Subject: Minutes for 55th Protection Sub-Committee Meeting.

55th Protection Sub-Committee Meeting (20th December, 2024)-MoM

Minutes of
55th Meeting of Protection Sub-Committee (PSC) of
Northern Regional Power Committee

DR of 400 KV Aligarh-Muradnagar 1 (end) (UP) Ckt

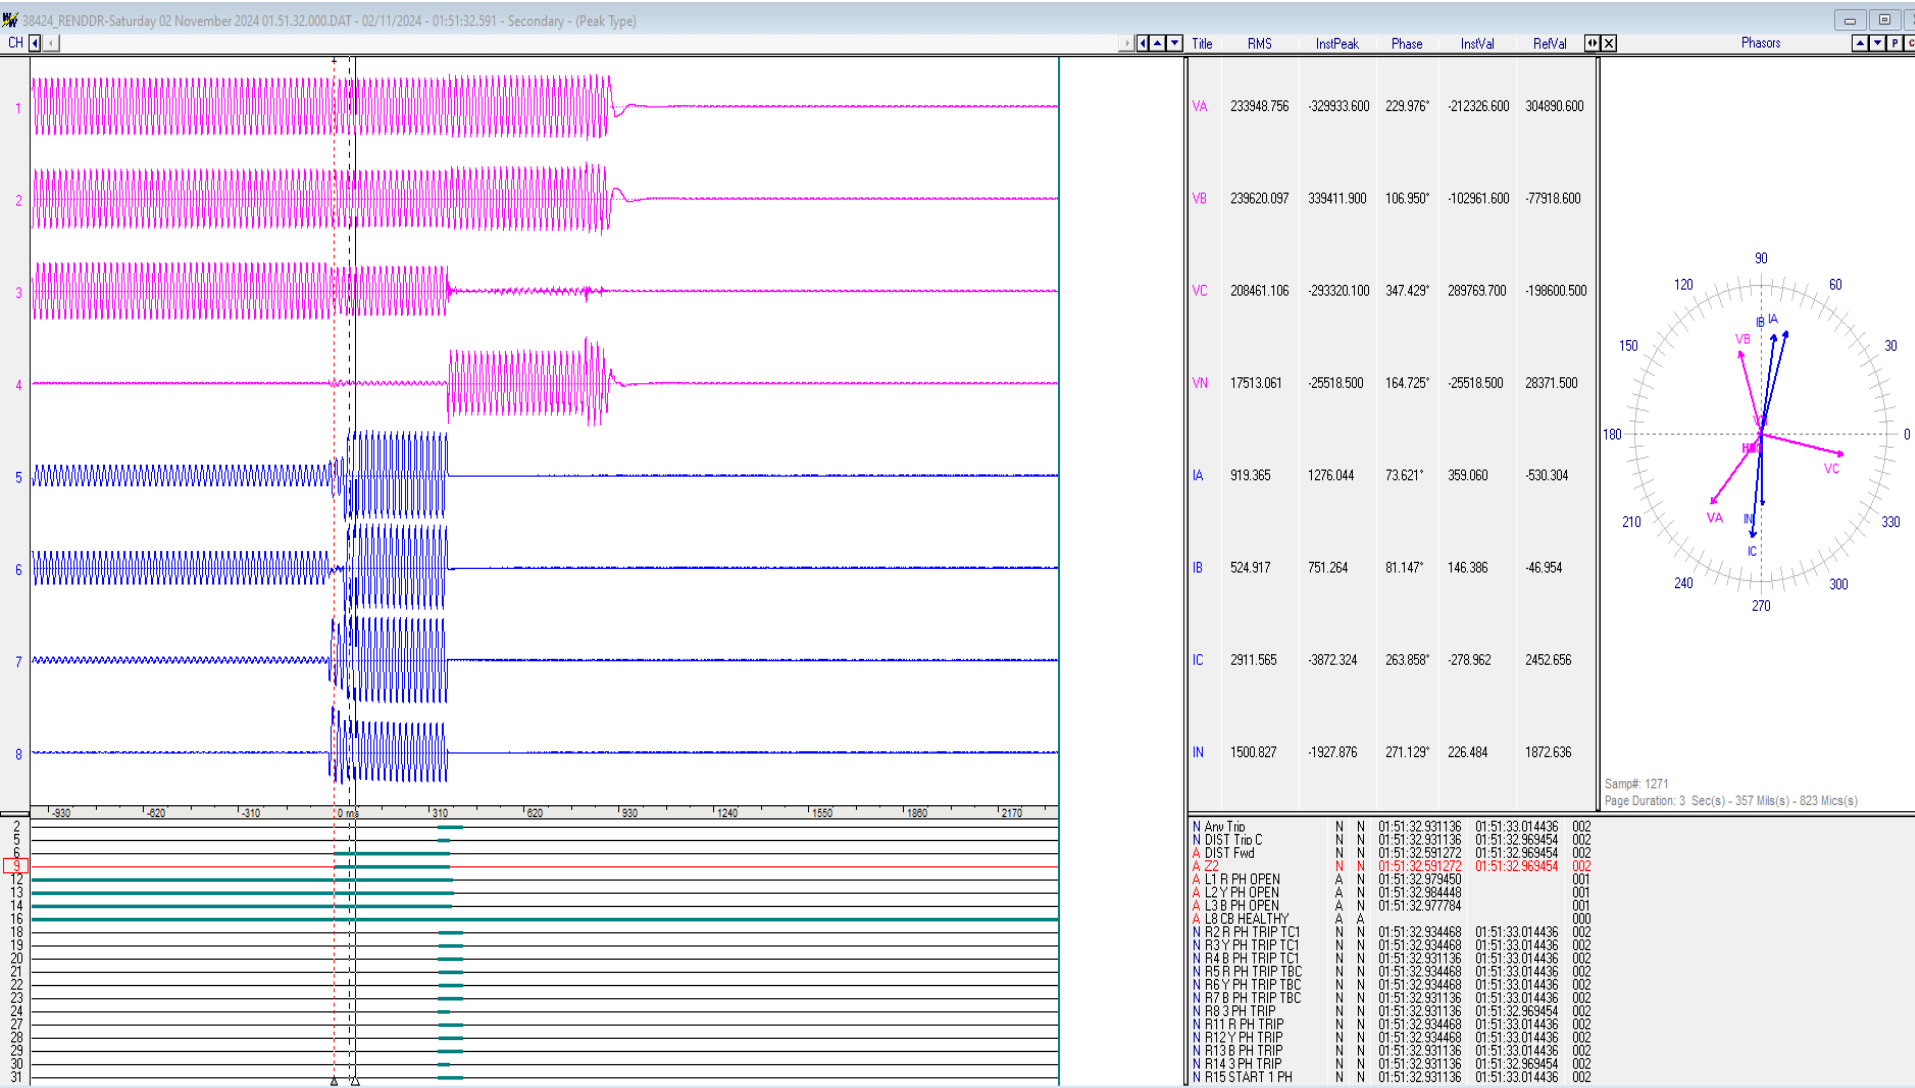
- ✓ B-N phase to earth fault; $I_b \approx 2.912 \text{ kA}$
- ✓ Fault sensed in zone-2 at Muradnagar_1 end
- ✓ Fault clearing time = $\sim 377 \text{ ms}$

DR of 400 KV Aligarh (end)-Muradnagar 1 (UP) Ckt

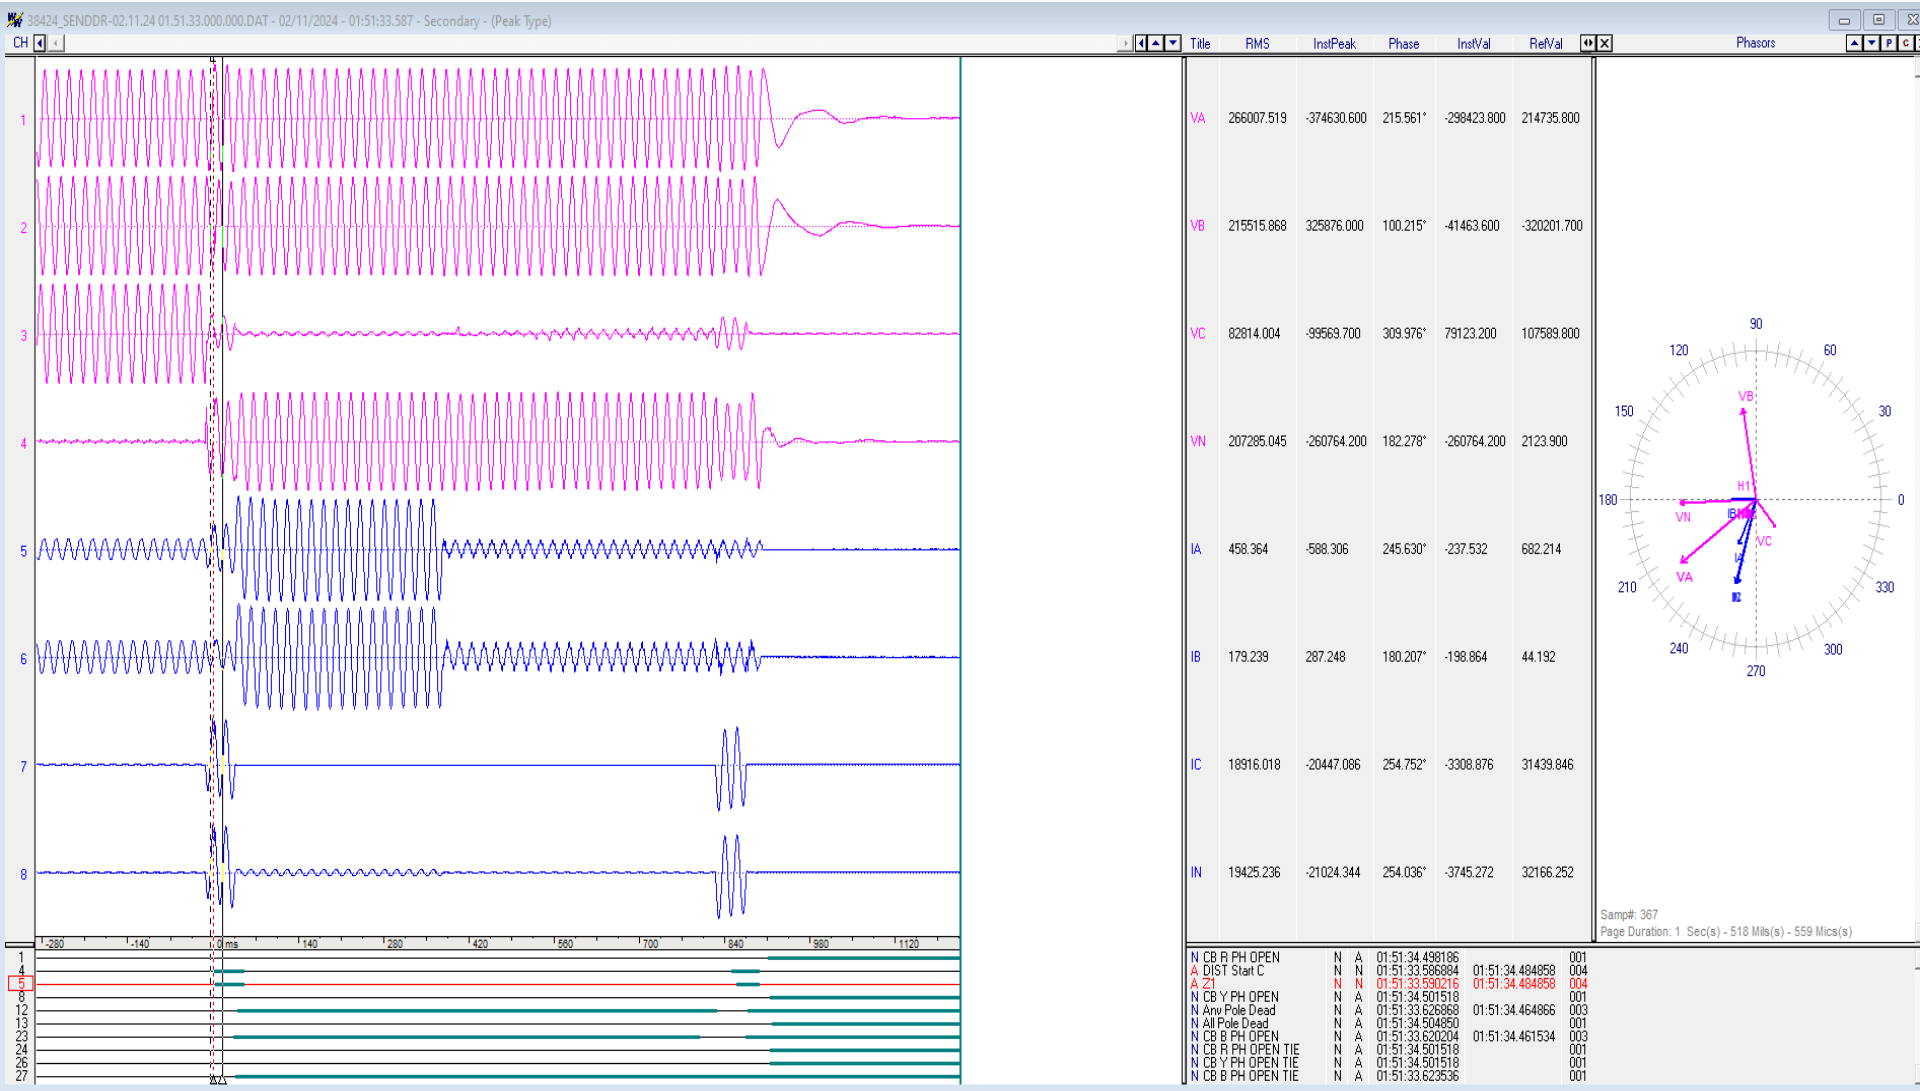
- DR of 400kV Aligarh-Shamli D/C was submitted showing high voltage in line.
- NRLDC representative highlighted that overvoltage was for small period of time and it dropped to ~ 1.05 pu within 1 sec. Drop off to pick up value may be reviewed.
- UPPTCL representative informed that drop off to pick up ration value was 95% and same has been revised to 99%.
- NRLDC representative raised concern over delayed clearance and A/R non-operation at Muradnagar_I(UP) end and suggested to review the carrier communication healthiness.
- UPPTCL representative informed that there is issue related to carrier communication at Muradnagar_I(UP) end. They will take necessary actions and resolve the issue.
- UPPTCL was also requested to review dead time setting at Aligarh (UP) end, it is ~ 840 msec. It may be set as standard value 1 sec.

- ✓ B-N phase to earth fault; $I_b \approx 18.916 \text{ kA}$
- ✓ Fault sensed in zone-1 at Aligarh end
- ✓ Unsuccessful A/R observed; A/R dead time = $\sim 840 \text{ ms}$

DR of 400 KV Aligarh (end) -Shamli (UP) Ckt-1 (Main 2)

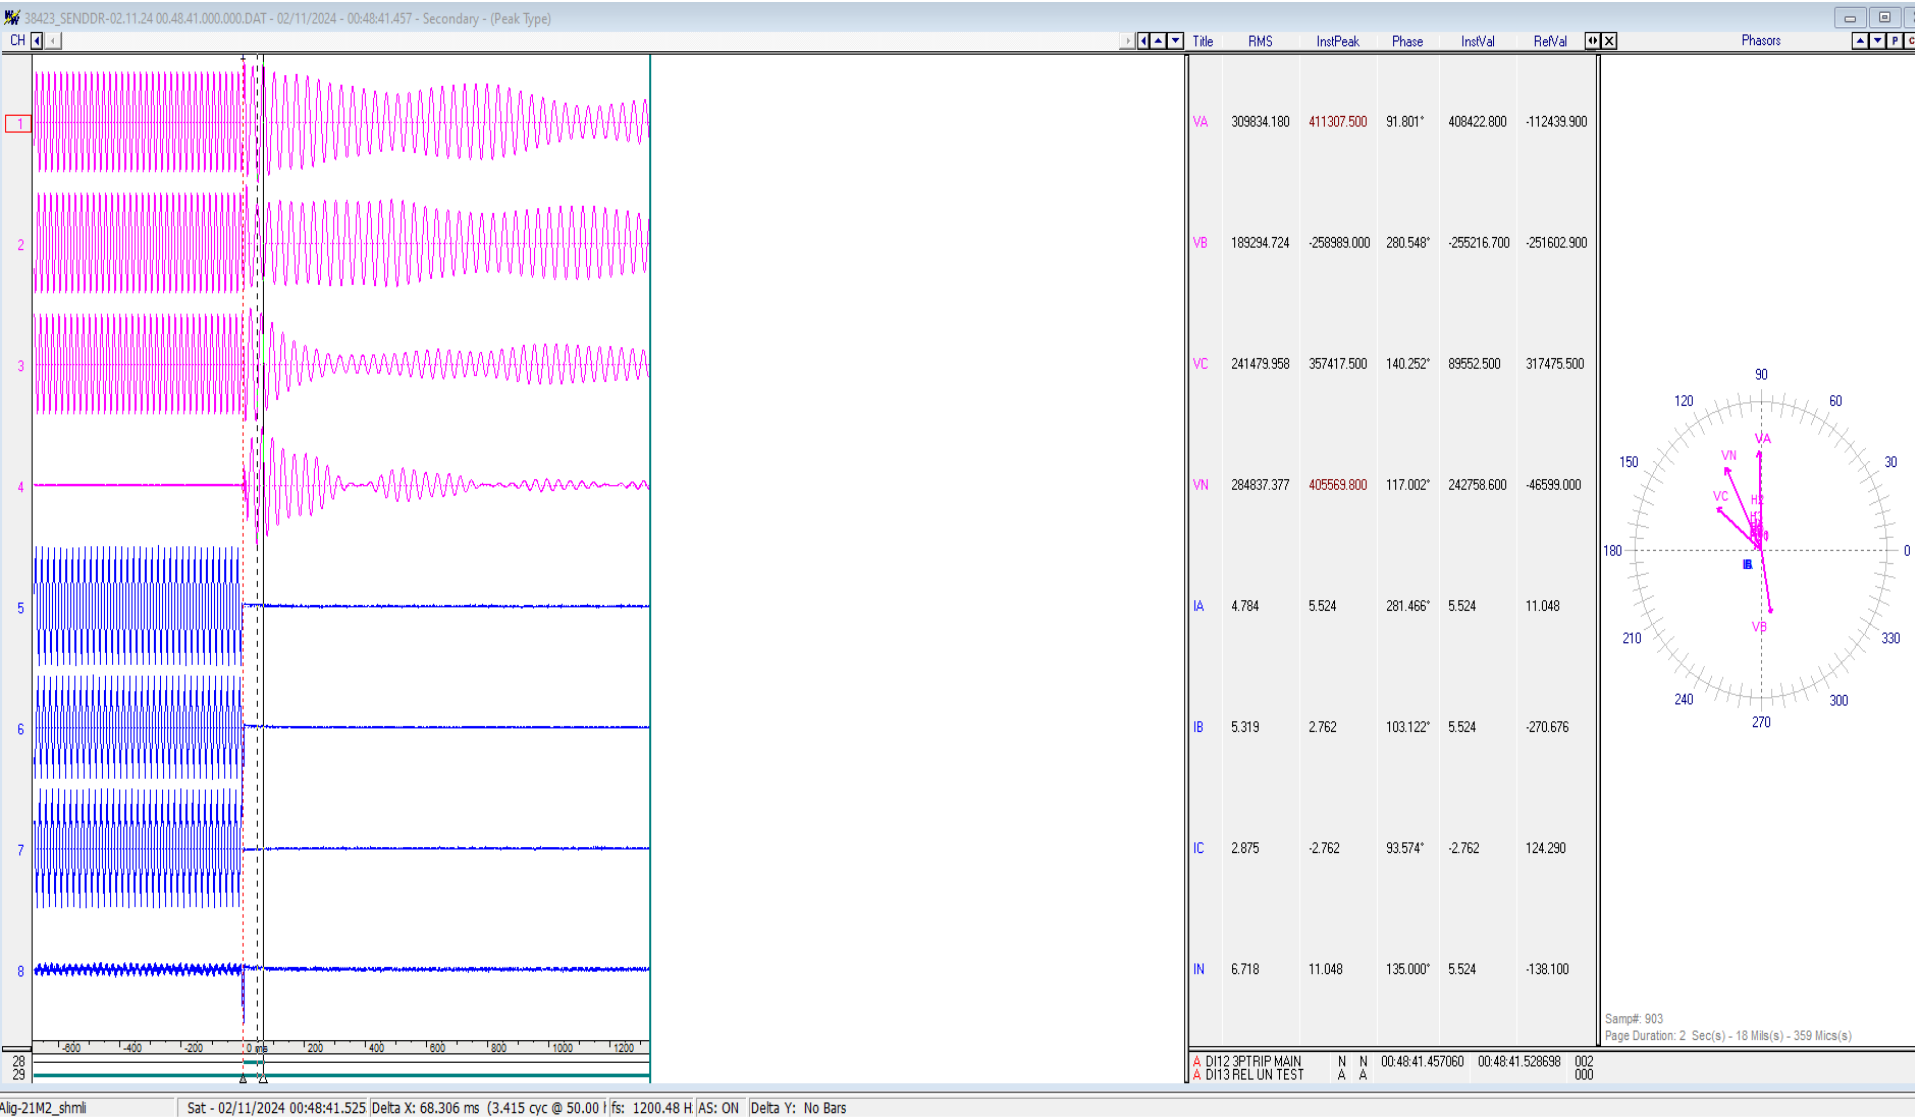
- ✓ R-ph voltage reached upto ~1.35 p.u.
- ✓ No flag in Main-2 relay at Aligarh
- ✓ Time sync issue observed

DR of 400 KV Aligarh (end) -Shamli (UP) Ckt-2 (Main 2)

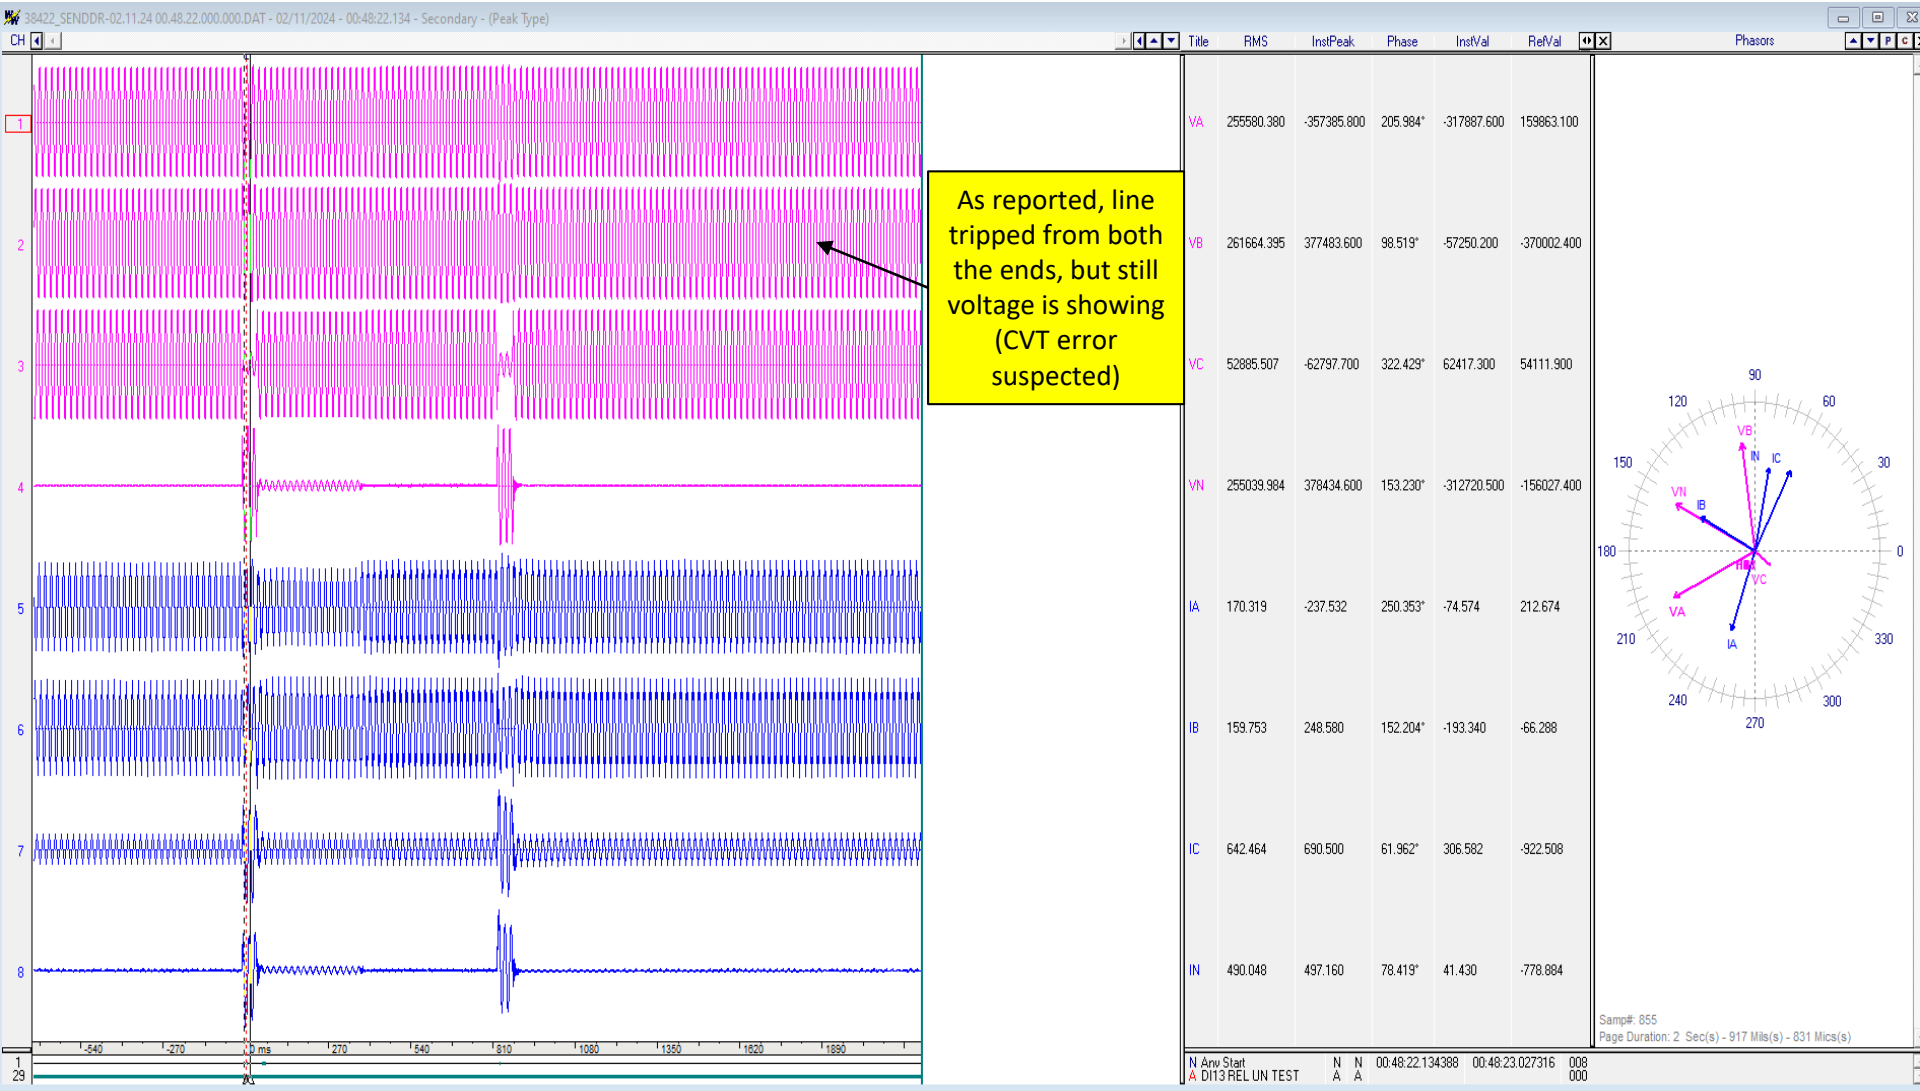
- ✓ B-N phase to earth fault; $I_b \approx 642A$
- ✓ No flag in Main-2 relay at Aligarh end
- ✓ Time sync issue observed

DR of 400 KV Hindaun(RS)-Chhabra(RVUN) (end) (RS) Ckt

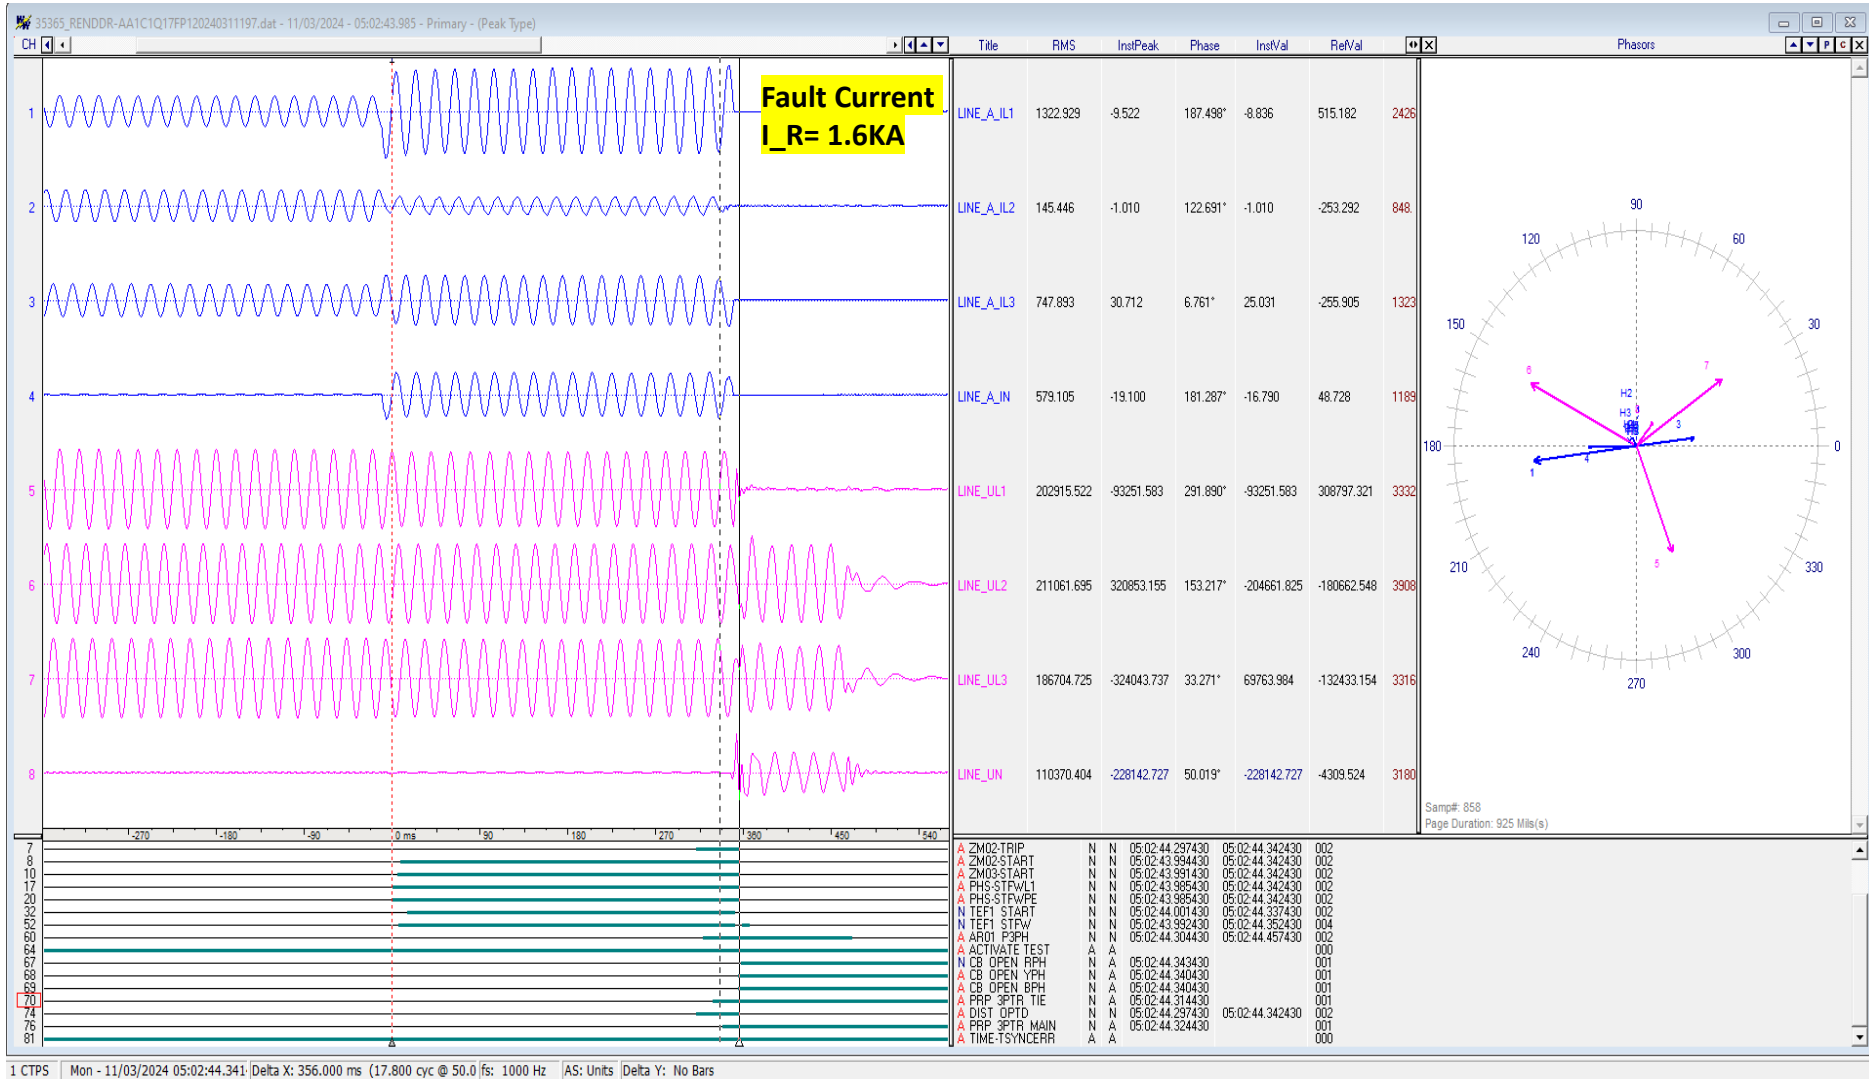
- ✓ Zone-2 distance protection operated at Chhabra end; fault clearing time= \sim 355ms
- ✓ DR nomenclature need to be corrected
- ✓ Time sync issue is observed
